ADDENDUM #2

1. Reference New Sketches:
 - .1 See sketches SK-5, SK-6, SK-7, and SK-8, attached to and forming part of this addendum, for associated electrical work.

REVISIONS:
 SHEET TITLE: Electrical Specification & Legend
 PROJECT TITLE: Englewood School Boiler Replacement Oil Option

CLIENT: PEI Department of Transportation Infrastructure & Energy

DEMOLITION FLOOR PLAN - OIL OPTION
3/8"=1'-0"

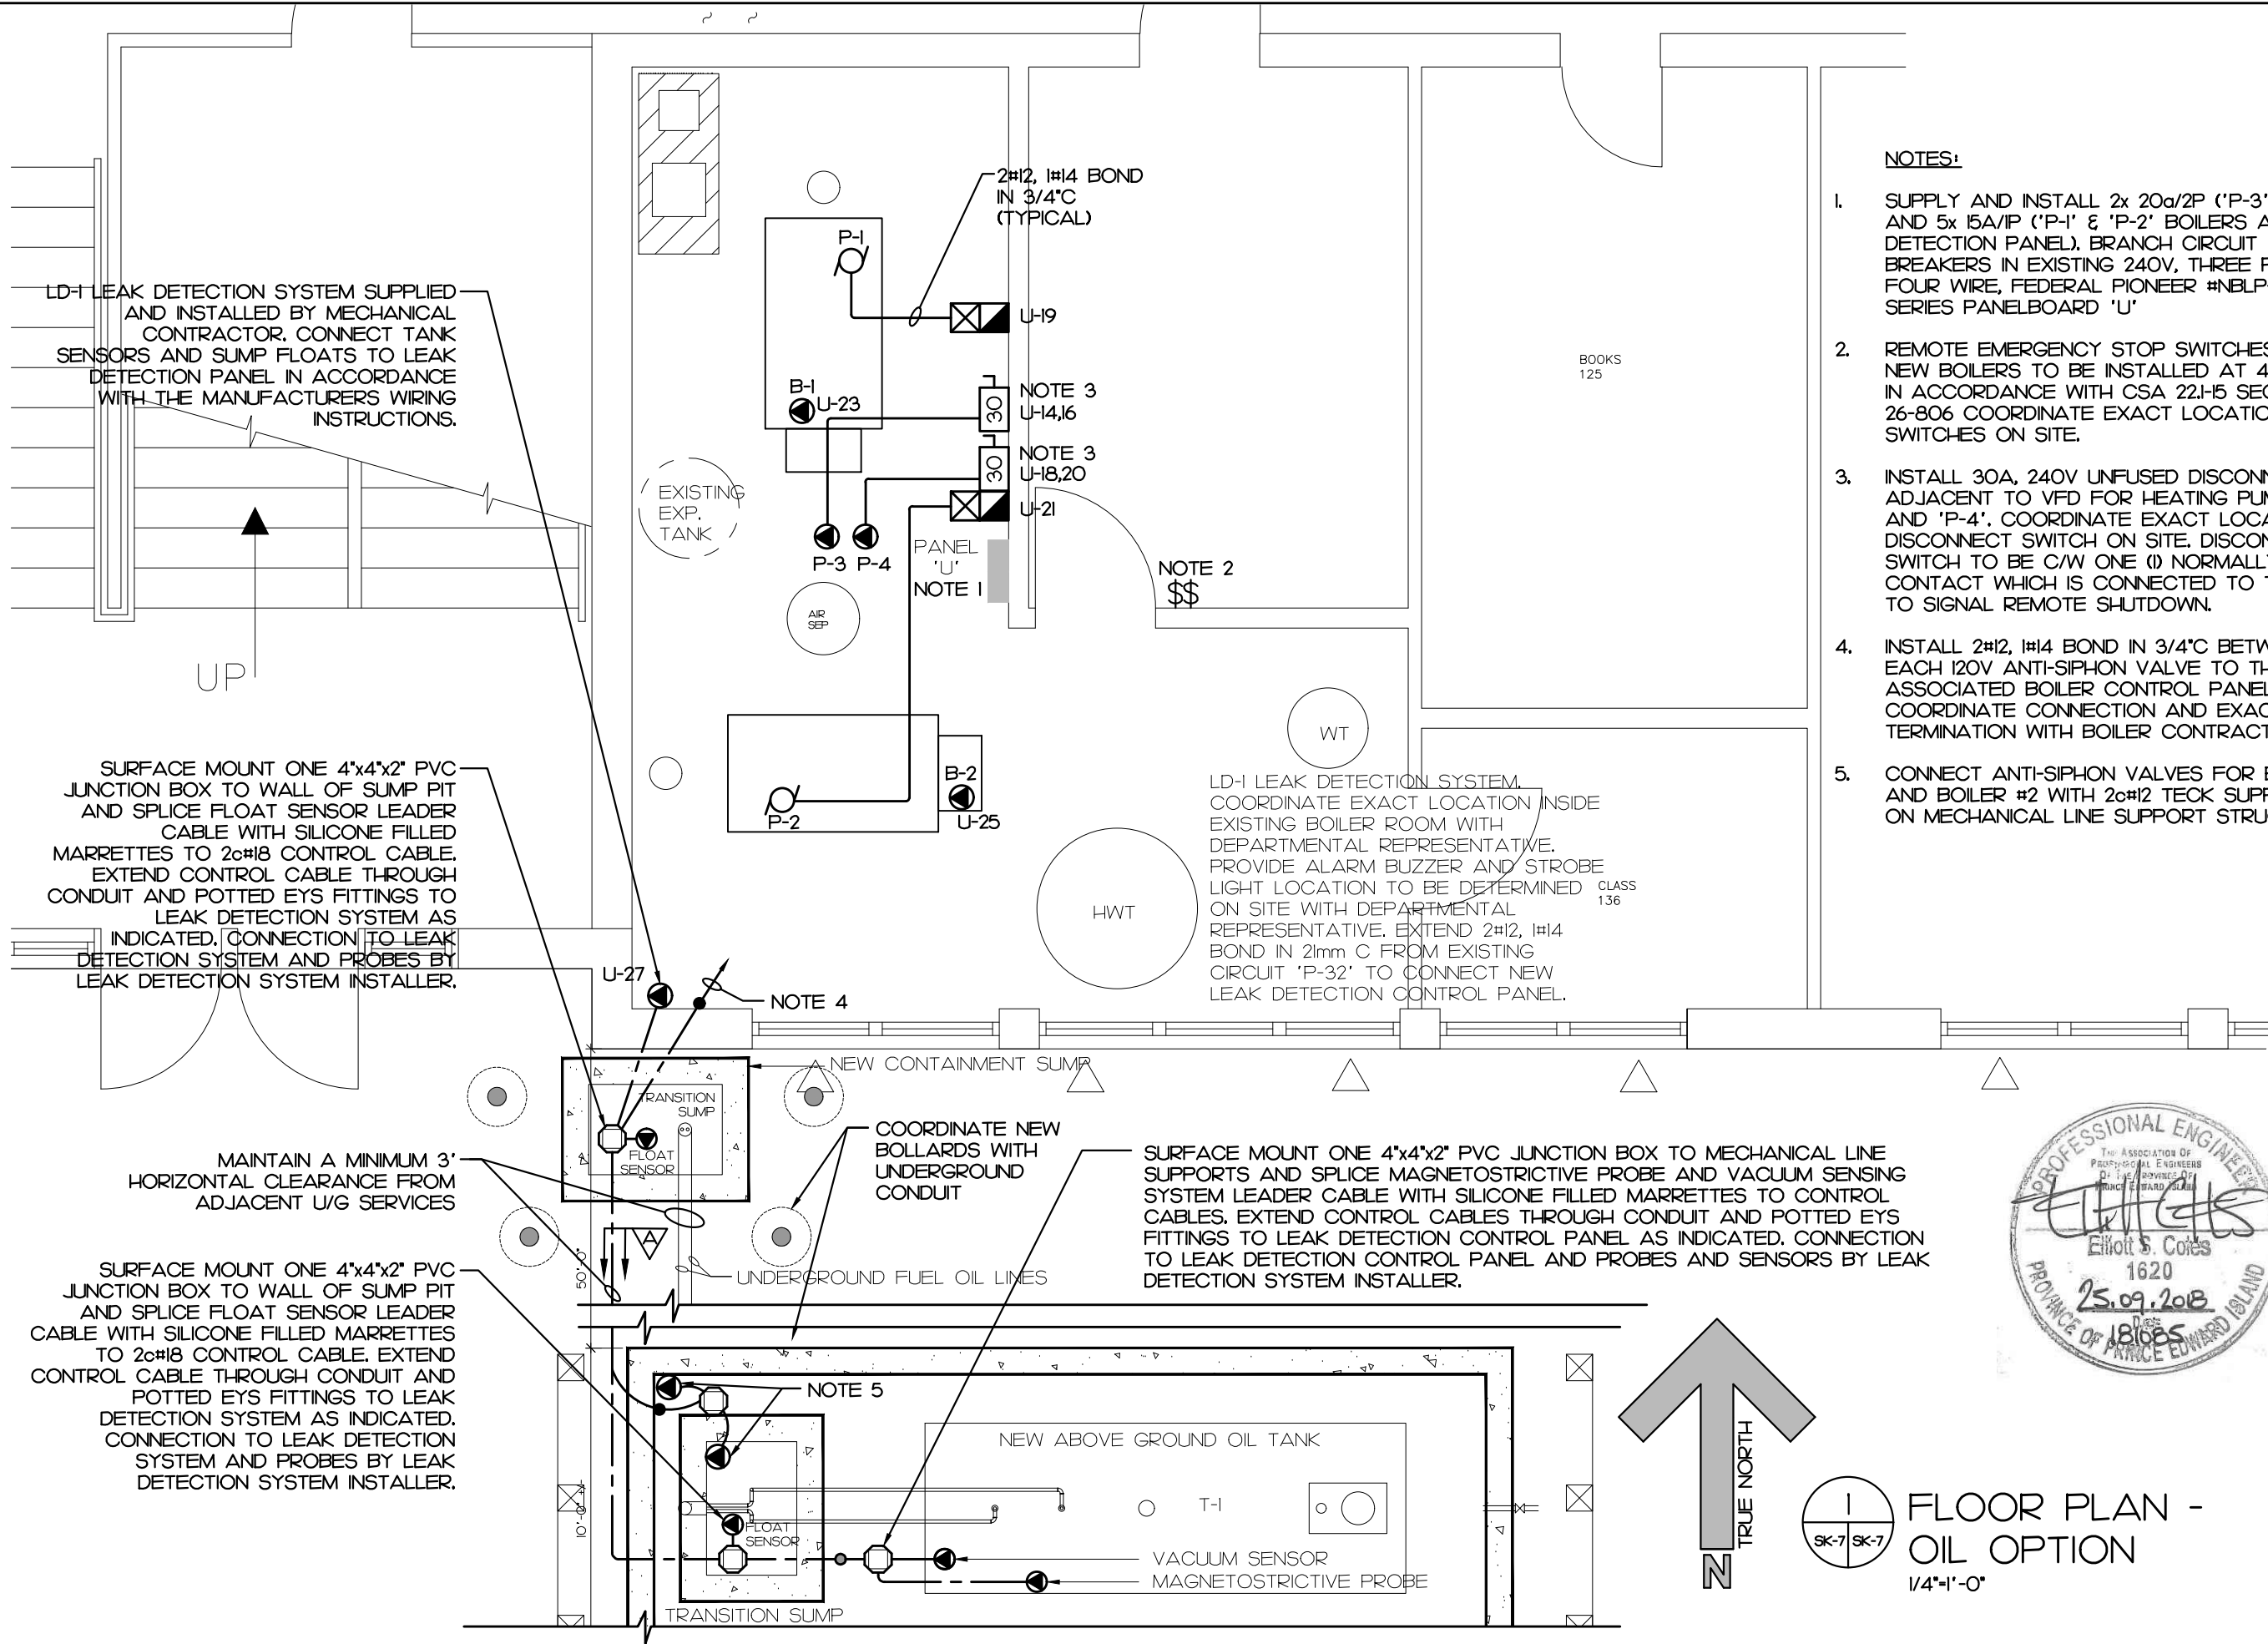
- NOTES:**
1. TRACE OUT, DISCONNECT, AND REMOVE ALL EXISTING ELECTRICAL ASSOCIATED WITH THE BOILER AND ASSOCIATED CIRCULATION PUMPS. EXISTING PANELBOARD AND BRANCH CIRCUIT BREAKER IN PANELBOARD TO REMAIN FOR FUTURE USE.
 2. TRACE OUT, DISCONNECT AND RELOCATE EXISTING REVERSE ACTING THERMOSTAT AND BRANCH CIRCUIT WIRING AS REQUIRED TO ACCOMMODATE NEW OIL BOILERS. COORDINATE EXACT LOCATION FOR REVERSE ACTING THERMOSTAT ON SITE WITH OWNER.

FLOOR PLAN - OIL OPTION
1/4"=1'-0"

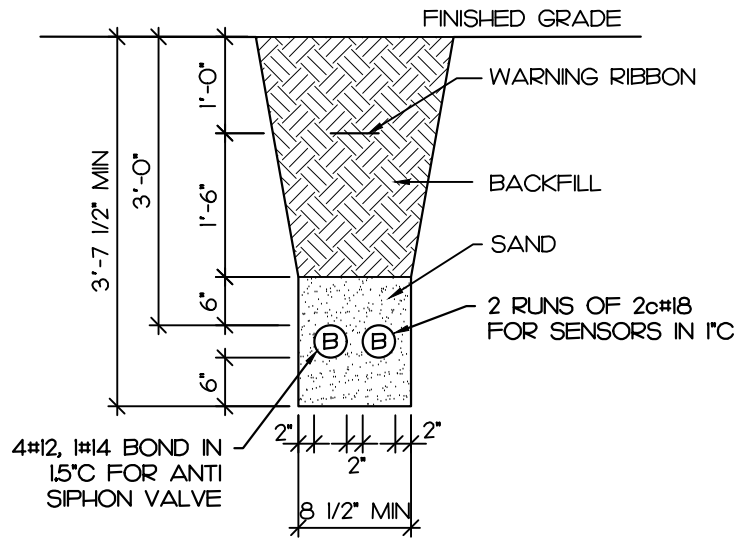
- NOTES:**
- SUPPLY AND INSTALL 2x 20a/2P ('P-3' & 'P-4') AND 5x 15A/1P ('P-1' & 'P-2') BOILERS AND LEAK DETECTION PANEL, BRANCH CIRCUIT BREAKERS IN EXISTING 240V, THREE PHASE, FOUR WIRE, FEDERAL PIONEER #NBLP-24-4L SERIES PANELBOARD 'U'

- REMOTE EMERGENCY STOP SWITCHES FOR NEW BOILERS TO BE INSTALLED AT 4'-7" AFF. IN ACCORDANCE WITH CSA 22.1-5 SECTION 26-806 COORDINATE EXACT LOCATION OF SWITCHES ON SITE.

- INSTALL 30A, 240V UNFUSED DISCONNECT ADJACENT TO VFD FOR HEATING PUMPS 'P-3' AND 'P-4'. COORDINATE EXACT LOCATION OF DISCONNECT SWITCH ON SITE. DISCONNECT SWITCH TO BE C/W ONE (1) NORMALLY OPEN CONTACT WHICH IS CONNECTED TO THE VFD TO SIGNAL REMOTE SHUTDOWN.

- INSTALL 2#12, 1#14 BOND IN 3/4"C BETWEEN EACH 120V ANTI-SIPHON VALVE TO THE ASSOCIATED BOILER CONTROL PANEL. COORDINATE CONNECTION AND EXACT TERMINATION WITH BOILER CONTRACTOR.

- CONNECT ANTI-SIPHON VALVES FOR BOILER #1 AND BOILER #2 WITH 2c#12 TECK SUPPORTED ON MECHANICAL LINE SUPPORT STRUCTURE.

CLIENT: PEI Department of Transportation Infrastructure & Energy
 PROJECT TITLE: Englewood School Boiler Replacement Oil Option
 SHEET TITLE: Trench Detail & Schematic
 DATE: Sept. 2018
 DRAWN BY: M.E.M., C.E.T.
 PROJECT NUMBER: 181085A
 DRAWING NUMBER: SK-8

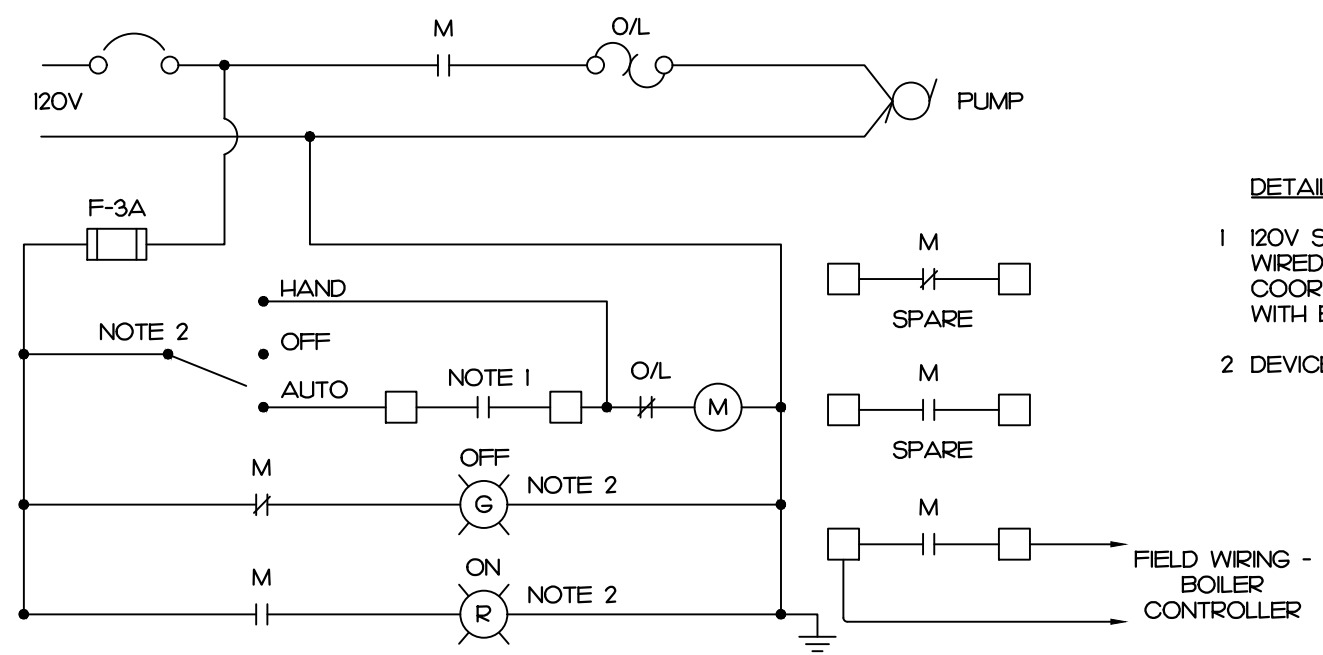
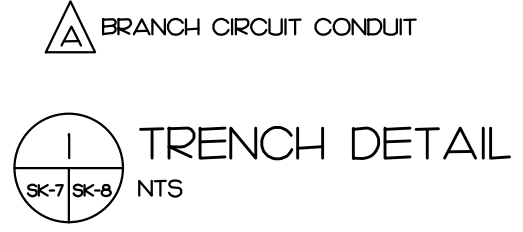
1. B = BRANCH CIRCUIT CONDUIT. QUANTITY AND SIZE AS INDICATED.
2. BACKFILLING OF TRENCH IN LAYERS NOT EXCEEDING 12" (MECHANICALLY TAMPED).
3. USE NEW SOIL FREE FROM LARGE ROCKS OR DEBRIS FOR BACKFILL.
4. IF SITE CONDITIONS PROHIBIT TRENCH AS PER THIS DRAWING, ADVISE CONSULTANT.
5. 1/4" DIA. NYLON ROPE INSTALLED IN ALL DUCTS.
6. ALL CONDUITS ARE TO BE LABELED WITH WEATHER PROOF TAGS INDICATING THE DESTINATION OF THE CONDUITS.
